1765 MONTREAL ROAD

URBAN DESIGN BRIEF

Submitted for Zoning By-Law amendment
10 April 2025

COMMENTS ON PRELIMINARY DESIGN

Original design as submitted for SPA 2022-12-23 (D07-12-22-0185)

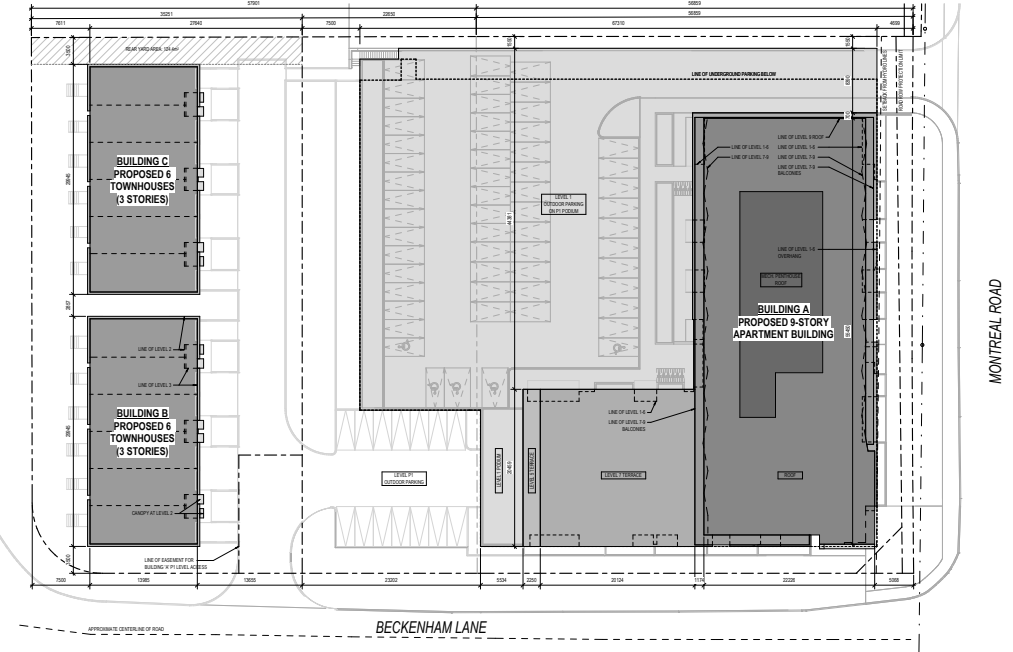
- *This project is within the City's Design Priority Area and will attend the UDRP.*
Noted.
- *We recommend providing a main entrance on Montreal Road. The previous entrance was at the intersection corner and appeared well-considered.*
The current proposal features a main entrance at the corner of Montreal and Beckenham.
- *We recommend the interior courtyard be designed as an amenity space, not a parking lot.*
We will add planting and landscaping as required to make the interior court feel like a meeting place instead of a parking lot.
- *We recommend limiting the tower floorplate to a maximum of 750m².*
We will respect the recommended 750m² floor plate area for the tower portion of the 17-story building

- *We recommend additional analysis to illustrate how the transition is provided to the neighboring property to the northeast.*
Since the proposed development is 17 storeys, we are mindful that it represents an increase in density in the area, and a number of measures have been used to assist with the transitioning of the building to the surrounding properties.

- *We recommend limiting the height of this building to four stories to align with the surrounding low-rise neighborhood condition and keeping the mid-rise built form (AM zone) closer to the Montreal Road corridor.*
The area of the side closest to the low-rise development on Cedar does not feature any development. Instead, this area will be used as a landscape buffer, parkland area, and 9 parking spaces. The northern building is located approximately 26 m from the northern property line. The majority of the development is considered mid-rise with sections at 5 and 7 storeys, and a 700 m2 floorplate area that extends up to 17 storeys. The densest portion of the development is closest to the Montreal Road corridor.

Measure 1 - Height of Building on Montreal Road: the proposed development has pushed the highest portion of the apartment building as close to Montreal Road, and the southern end of the lot as possible. This helps the building appropriately respond to the bigger and faster scale of Montreal Road, while helping reduce shadows cast by the building on neighbouring properties.

Measure 2 - Stepping Down of Apartment Building: the apartment building steps down towards Cedar Road at level 7, providing a communal terrace with views towards the Ottawa River, and again at level 5. This stepping down of the built form helps to transition the heavier mass towards the lower density residential buildings of the neighbourhood to the north.

Measure 3 - Tree Conservation: the existing tree cover along the property line on Cedar road helps to buffer this transition in height.
